CONCEPT SITE PLAN OVERLAY - NOT FOR CONSTRUCTION - NOT A SURVEY

OPTION 1 - PLAN MIRRORED (GARAGE ON WEST, DRIVEWAY SIDE); HOUSE PARALLEL WITH SIDE LOT LINES

EXISTING CONDITIONS PLAN

LOCATION: 199 CENTRAL STREET

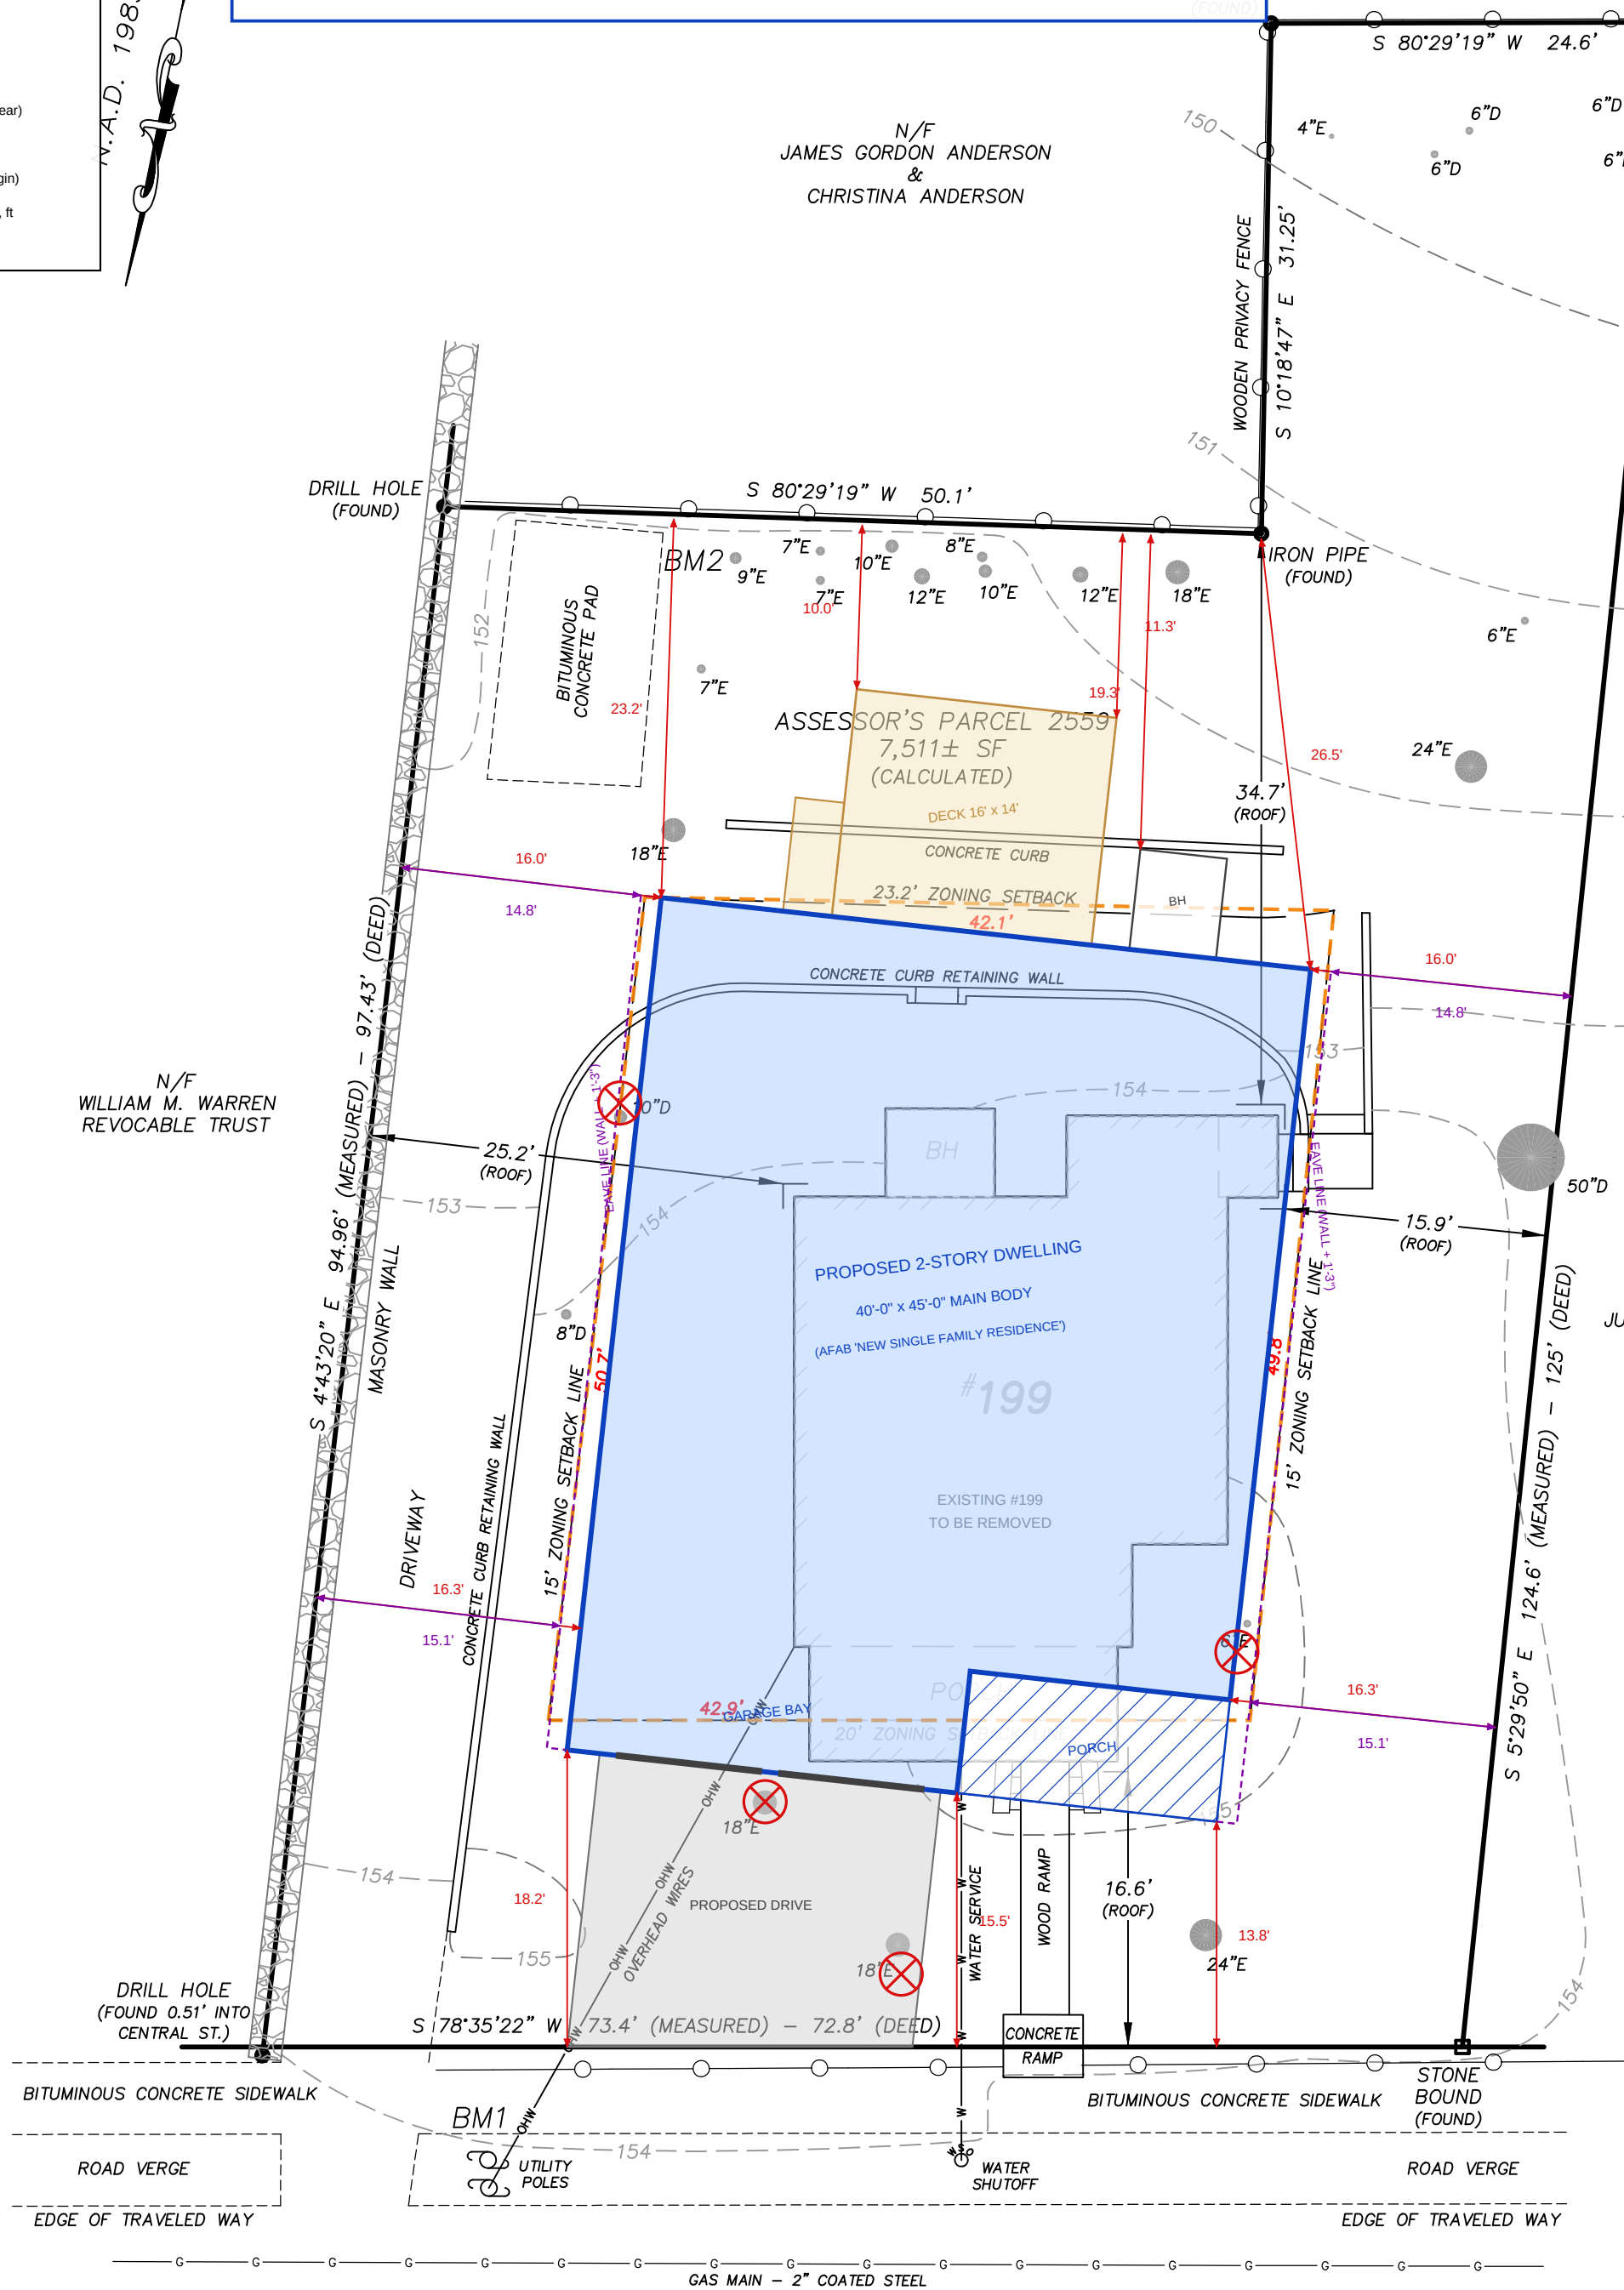
PLACEMENT
House axis parallel with the mean bearing of the side lot lines: 6.3 deg clockwise from the sheet vertical (west line S 4-43-20 E leans 6.7 deg, east line S 5-29-50 E leans 5.9 deg). Main body centred between the side setback lines (16.0' / 16.0' to the lot lines) with its rear wall on the rear setback line; main-body front wall 21.2' from Central Street at the east corner. The main body can slide only 1.3' toward the street before it reaches the 20' front line; each foot of slide reduces the rear-yard encroachment of the deck/bulkhead by a foot and increases the rear-yard encroachment of the garage/porch by a foot.

SETBACK CHECK (front 20' / sides 15' / rear 23.2')
Main body 40'x45': 21.2' street, 16.0' W, 16.0' E, 23.2' rear - COMPLIES (1.0' spare each side).
Garage bay (WEST): 15.5' to 18.2' from street - 4.5' INSIDE the front setback.
Covered porch (EAST): 13.8' to 15.5' from street - 6.2' INSIDE the front setback.
Rear deck: 10.0' to 11.3' from rear lot line - 13.2' INSIDE the rear setback.
Bulkhead: 19.3' from rear lot line - 3.9' INSIDE the rear setback.
=> The enclosed house as drawn does NOT fit the envelope in any orientation: a 40'-wide rectangle parallel with the lot can be at most ~46.3' deep here, vs. 52'-6" for this plan. Sheet 4 shows the largest front projection that fits (3'-0" with the garage on the west, 1'-3" with it on the east); the memo lists the relief/redesign options.

ROOF OVERHANG (owner's rule: 12" side eave + 3" margin = 1'-3" beyond each side wall)
Eave line (purple) is 15.05' / 14.76' from the west lot line and 15.09' / 14.79' from the east lot line at the front / rear corners, i.e. 2.9' INSIDE the 15' side setback at both rear corners and 0.7' clear at the front corners. The envelope narrows toward the rear, so the rear ~37' of eave sits inside the line. A 40'-0" body cannot hold 1'-3" on both sides anywhere on this lot: the most it can hold is 12.4" per side (rotation does not help; parallel is already the best angle). To keep the rule, narrow the main body to 39'-6" (max 39.56' wall to wall) or reduce the side overhang to about 9" on the rear 37' of the house. Front/rear rake overhangs are NOT allowed for here; if the Town measures those too, the main body loses another 1'-3" of depth at the rear.

SITE, TREES, UTILITIES
Trees within 3' of the footprint or drive (marked X): 18"E, 18"E, 6"E, 10"D.
Protected trees (>= 6" DBH in the setback strips, Tree Preservation Bylaw): 50"D, 24"E, 18"E, 18"E, 18"E, 10"D, 8"D, 18"E, 12"E.
50" deciduous tree on the east line is ~15' from the nearest proposed structure; keep excavation and the drive out of its root zone (arborist review).
Existing water service (centre of lot), overhead electric from the poles at the SW corner, the concrete-curb retaining wall and the bituminous pad at the rear are all affected - re-route/remove as required. The existing west-side driveway/curb cut can be closed and restored or kept as a parking pad; the new apron needs a CPW driveway permit.
Grade falls ~5' from Central St (el. 155) to the rear line (el. 150-151), so the deck and bulkhead will stand well above grade; AFAB's bulkhead size may vary note applies.

PERMITTING FLAGS (from bylaw research - confirm with Town staff)
1. Pre-existing nonconforming lot: a replacement house over 150% of the existing gross floor area needs a ZBA special permit (Sec. 7.1.5 / 11.6); the 3,387 sf plan is well over that unless the existing house is > 2,258 sf. Precedents show the ZBA routinely grants these when setbacks are met - encroachments (above) weaken the case.

OPTION 2 - PLAN AS DRAWN (GARAGE ON EAST); HOUSE PARALLEL WITH SIDE LOT LINES

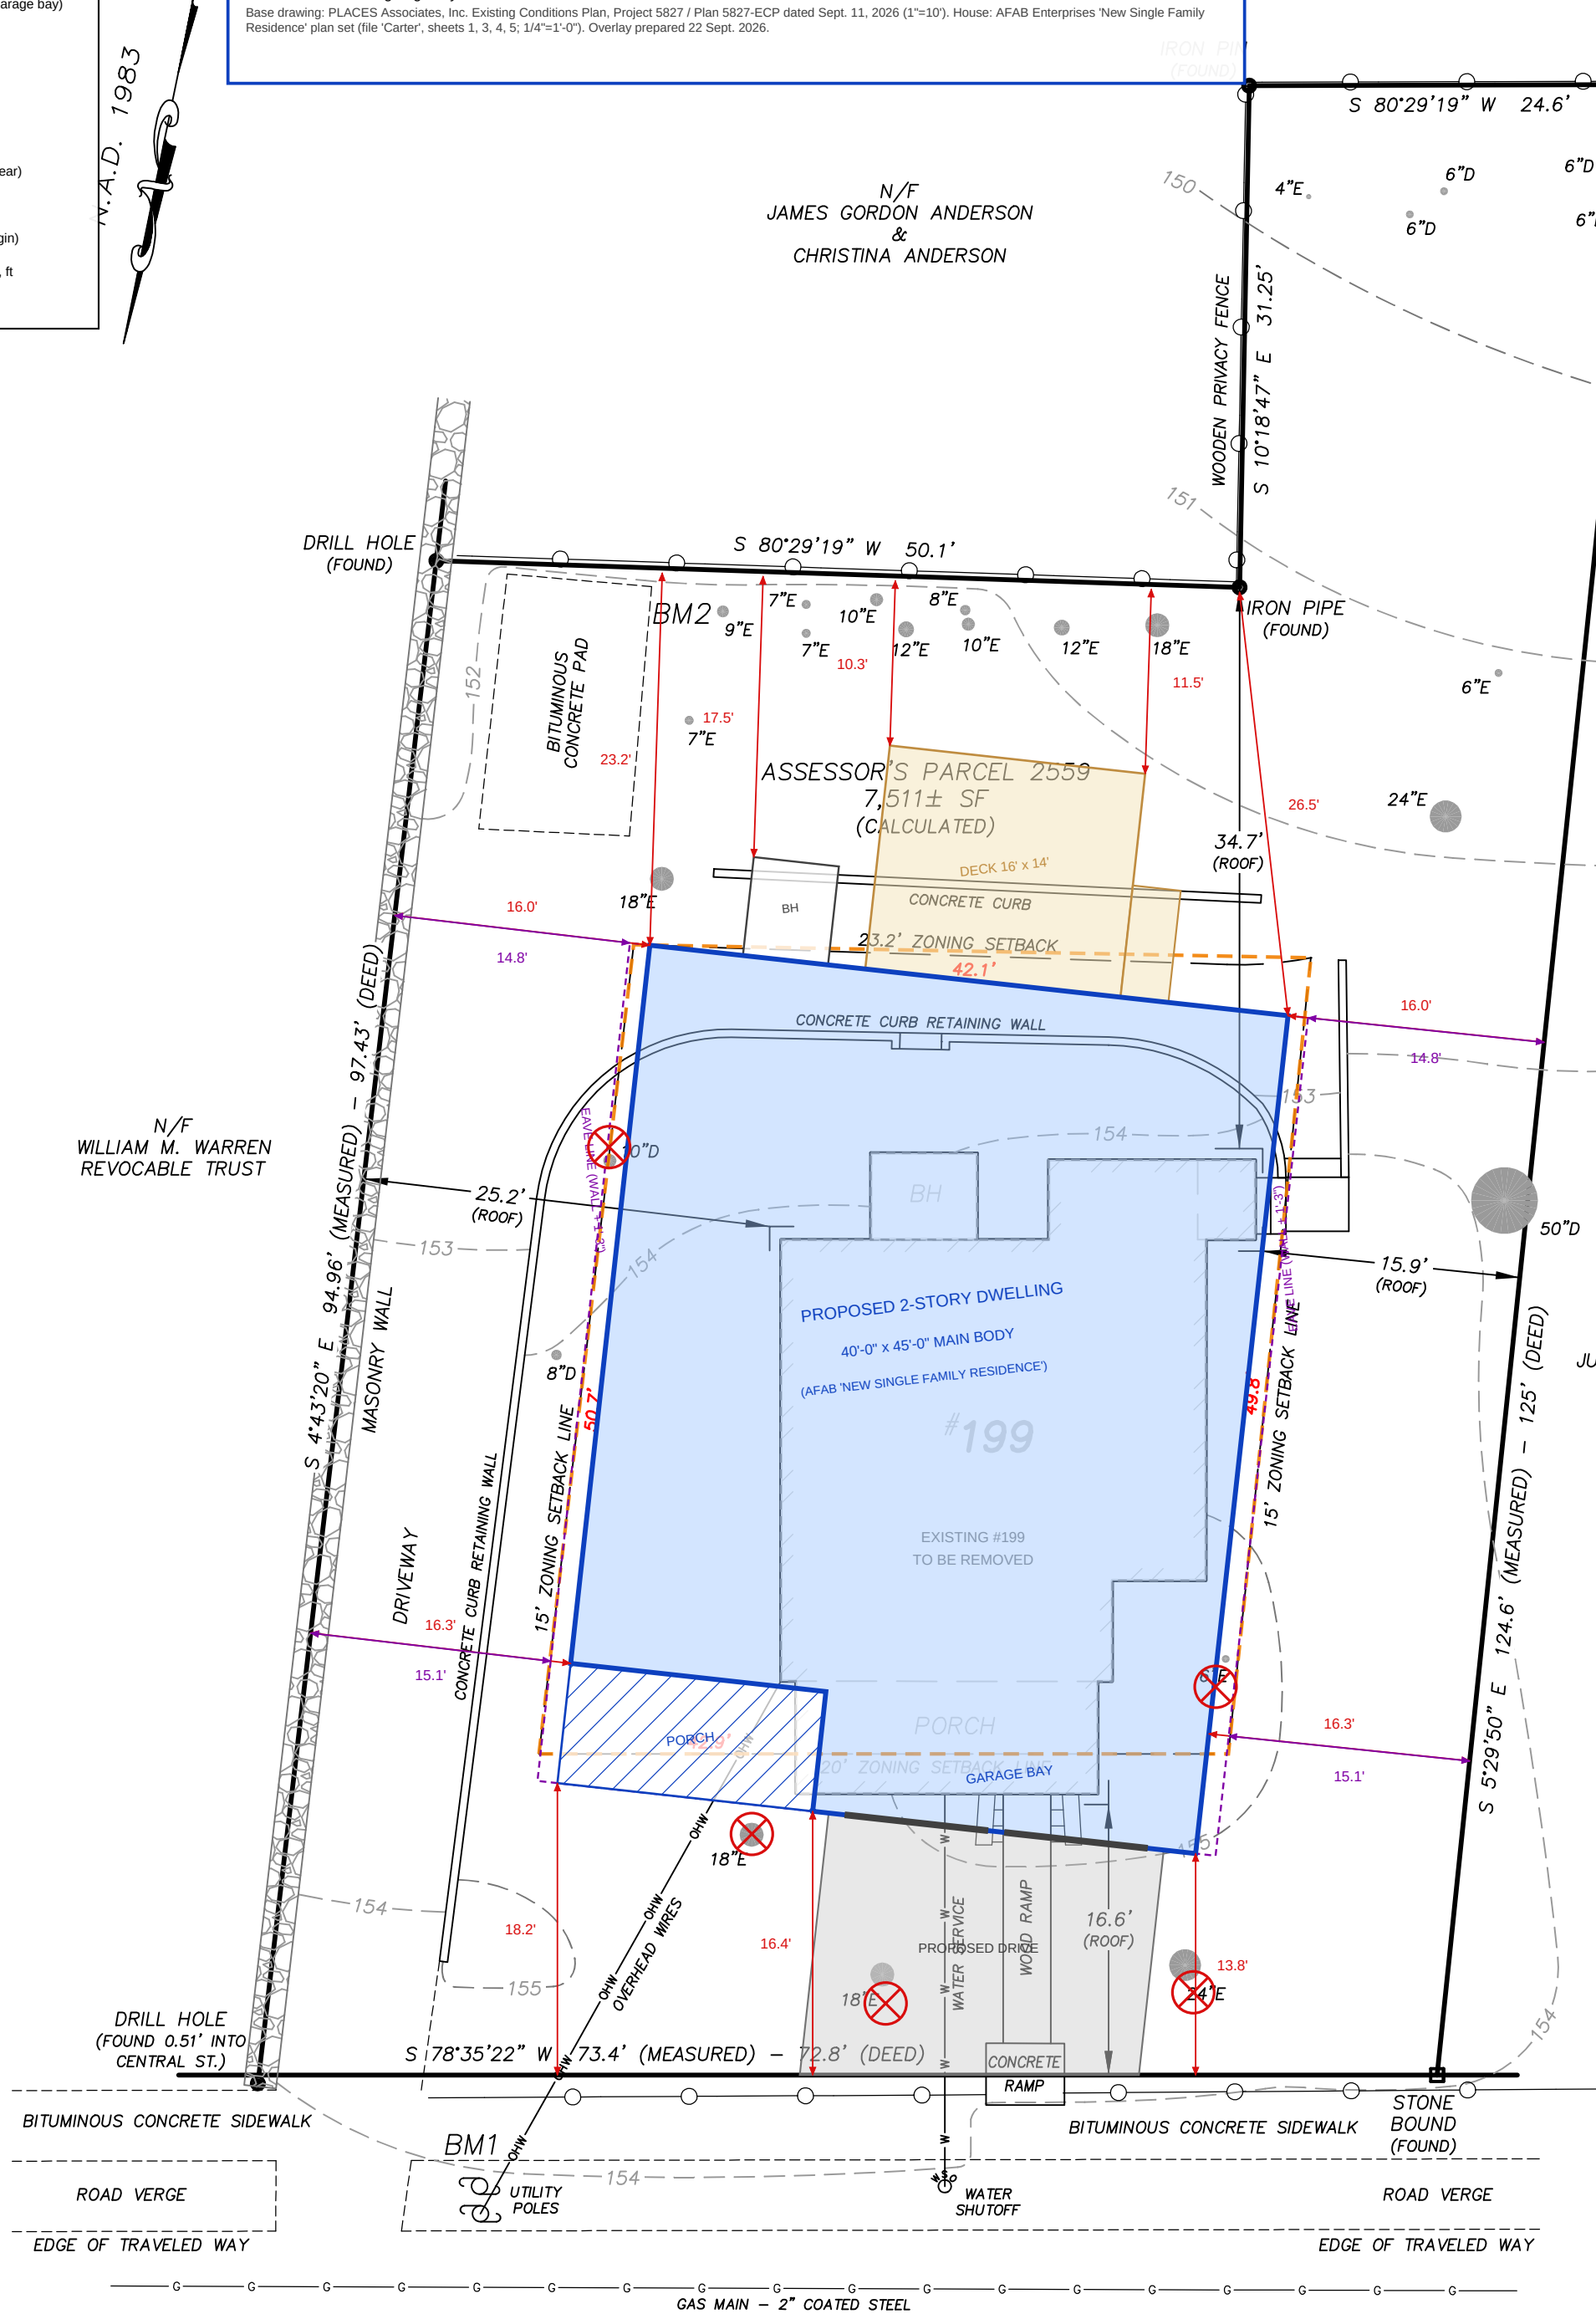
House axis parallel with the mean bearing of the side lot lines: 6.3 deg clockwise from the sheet vertical (west line S 4-43-20 E leans 6.7 deg, east line S 5-29-50 E leans 5.9 deg). Main body centred between the side setback lines (16.0' / 16.0' to the lot lines) with its rear wall on the rear setback line; main-body front wall 21.2' from Central Street at the east corner. The main body can slide only 1.3' toward the street before it reaches the 20' front line; each foot of slide reduces the rear-yard encroachment of the deck/bulkhead by a foot and increases the front-yard encroachment of the garage/porch by a foot.

Main body 40'x45': 21.2' street, 16.0' W, 16.0' E, 23.2' rear - COMPLIES (1.0' spare each side). Garage bay (EAST): 13.8' to 16.4' from street - 6.2' INSIDE the front setback. Covered porch (WEST): 16.4' to 18.2' from street - 3.6' INSIDE the front setback. Rear deck: 10.3' to 11.5' from rear lot line - 12.9' INSIDE the rear setback. Bulkhead: 17.5' from rear lot line - 5.7' INSIDE the rear setback. => The enclosed house as drawn does NOT fit the envelope in any orientation: a 40'-wide rectangle parallel with the lot can be at most -46.3' deep here, vs. 52'-6" for this plan. Sheet 4 shows the largest front projection that fits (3'-0" with the garage on the west, 1'-3" with it on the east); the memo lists the relief/redesign options.

ROOF OVERHANG (owner's rule: 12" side eave + 3" margin = 1'-3" beyond each side wall) Eave line (purple) is 15.05' / 14.76' from the west lot line and 15.09' / 14.79' from the east lot line at the front / rear corners, i.e. 2.9' INSIDE the 15' side setback at both rear corners and 0.7' clear at the front corners. The envelope narrows toward the rear, so the rear -37' of eave sits inside the line. A 40'-0" body cannot hold 1'-3" on both sides anywhere on this lot: the most it can hold is 12.4" per side (rotation does not help; parallel is already the best angle). To keep the rule, narrow the main body to 39'-6" (max 39.56' wall to wall) or reduce the side overhang to about 9" on the rear 37' of the house. Front/rear rake overhangs are NOT allowed for here; if the Town measures those too, the main body loses another 1'-3" of depth at the rear.

Trees within 3' of the footprint or drive (marked X): 24"E, 18"E, 18"E, 6"E, 10"D. Protected trees (>= 6" DBH in the setback strips, Tree Preservation Bylaw): 50"D, 24"E, 18"E, 18"E, 18"E, 24"E, 10"D, 8"D, 18"E, 12"E. 50" deciduous tree on the east line is ~15' from the nearest proposed structure; keep excavation and the drive out of its root zone (arborist review). Existing water service (centre of lot), overhead electric from the poles at the SW corner, the concrete-curb retaining wall and the bituminous pad at the rear are all affected - re-route/remove as required. A new east-side curb cut is needed; the existing west driveway would be abandoned. Grade falls ~5' from Central St (el. 155) to the rear line (el. 150-151), so the deck and bulkhead will stand well above grade; AFAB's bulkhead size may vary note applies.

1. Pre-existing nonconforming lot: a replacement house over 150% of the existing gross floor area needs a ZBA special permit (Sec. 7.1.5 / 11.6); the 3,387 sf plan is well over that unless the existing house is > 2,258 sf. Precedents show the ZBA routinely grants these when setbacks are met - encroachments (above) weaken the case.
